Re: Application for approval of the amalgamation of Niagara West Transformation Corporation and Grimsby Power Inc. under subsection 86(1)(c) of the *Ontario Energy Board Act, 1998* and related relief – Board File No. EB-2014-0344

**RESPONSES OF GRIMSBY POWER INC. AND NIAGARA
WEST TRANSFORMATION CORPORATION TO BOARD
STAFF INTERROGATORIES**

**RESPONSES OF GRIMSBY POWER INC. AND NIAGARA
WEST TRANSFORMATION CORPORATION TO NIAGARA
PENINSULA ENERGY INC. INTERROGATORIES**

NWI-100 Rev 12 – NWTS Station Single Line Diagram

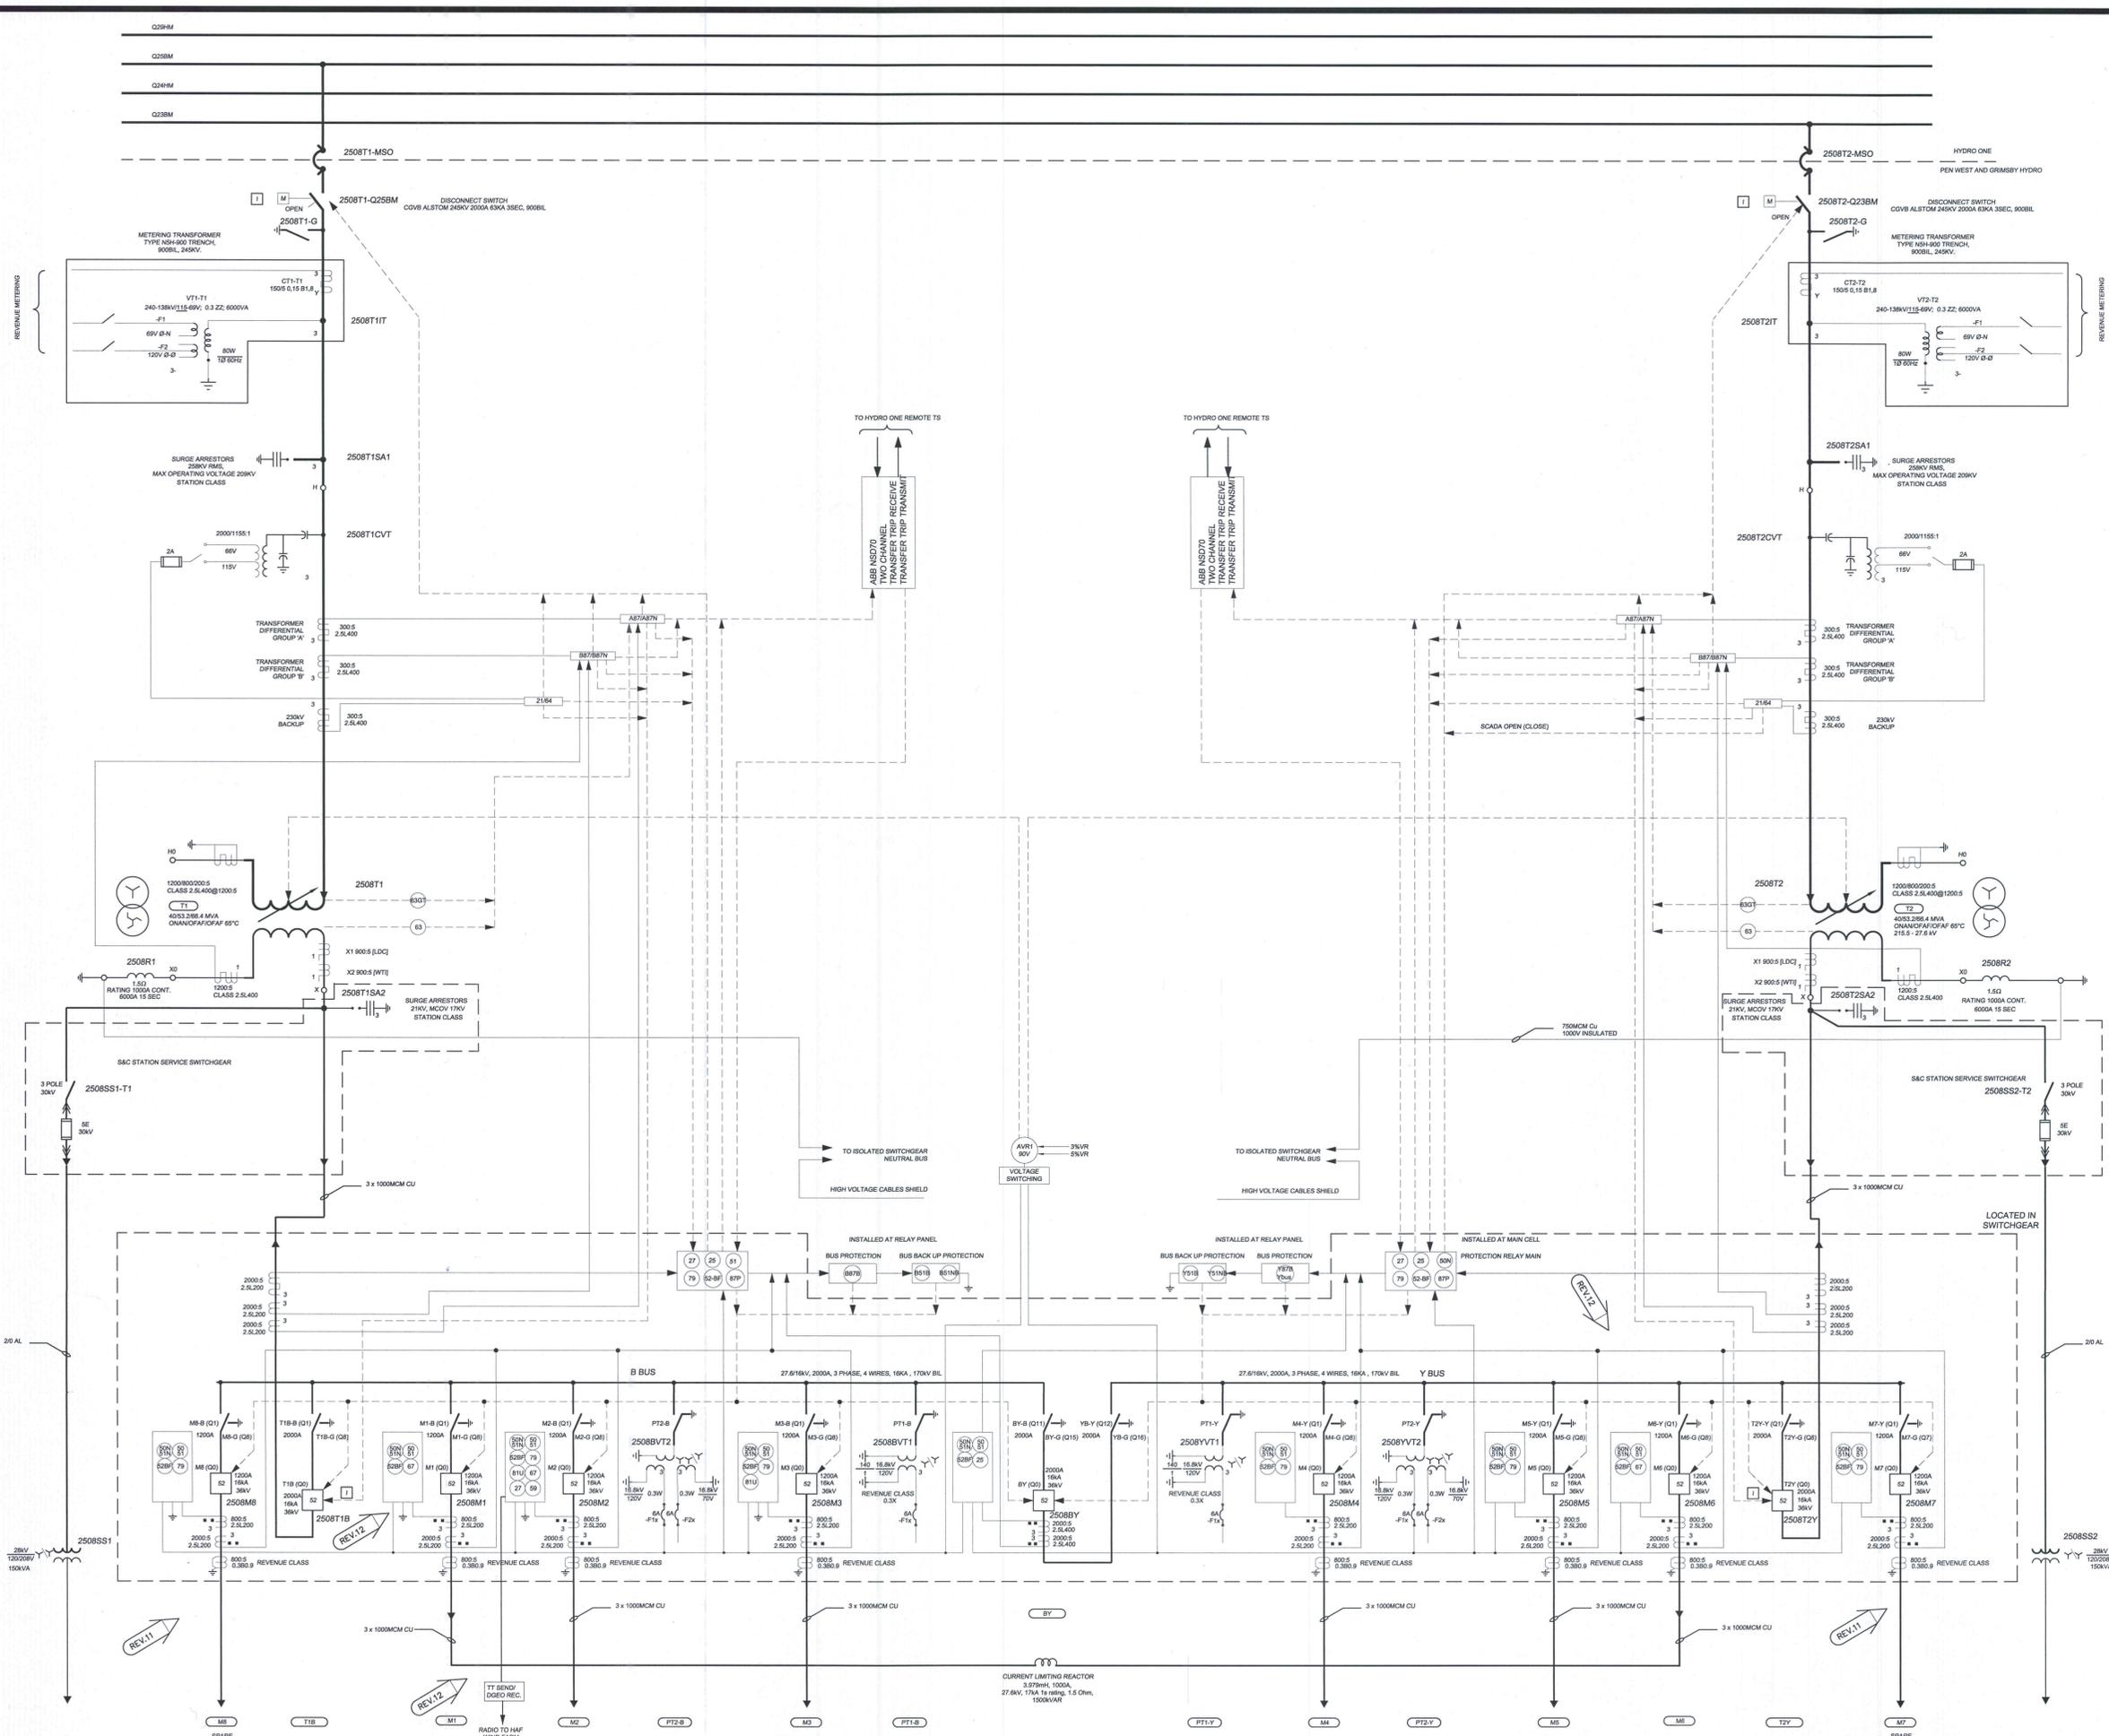
(b) Can you provide an overview drawing of the transformer station and the distribution circuits exiting the transformer station, including metering and designation of location of ownership changes?

- NW1-100 Rev 12 – NWTs Station Single Line Diagram – This is an electrical overview of the station which includes the distribution feeders leaving the station.
- Niagara West MTS – MP ID # 104298 – This describes the primary metering at the station.

On the 230kV high voltage side of the station the ownership demarcation point is noted on drawing NW1-100 Rev 12. This demarcation point is the 2508T1-MSO and 2508T2-MSO (230kv line jumpers from the Hydro One transmission line to the station) noted towards the top of the drawing – Hydro One/Pen West and Grimsby Hydro.

The revenue metering inside the station is located on each of the 230kV incoming circuits. Four distribution feeders at 27.6kv leave the station via underground cables and terminate on four wood poles on road allowance in front of the station. At each of these termination poles the underground cables are connected to overhead 27.6kv line which distributes the electrical supply to GPI and NPEI customers. GPI has two primary metering units (PMU's) for revenue metering on each of its two 27.6kV circuits. Each of these PMU's is located inside GPI's service territory. NPEI has two 27.6kV circuits which are not revenue metered. The separation of the transmission asset to distribution asset is on the load side of each feeder breaker where the underground cable is connected to the switchgear in the station. This point is physically located inside the switchgear building of the station.
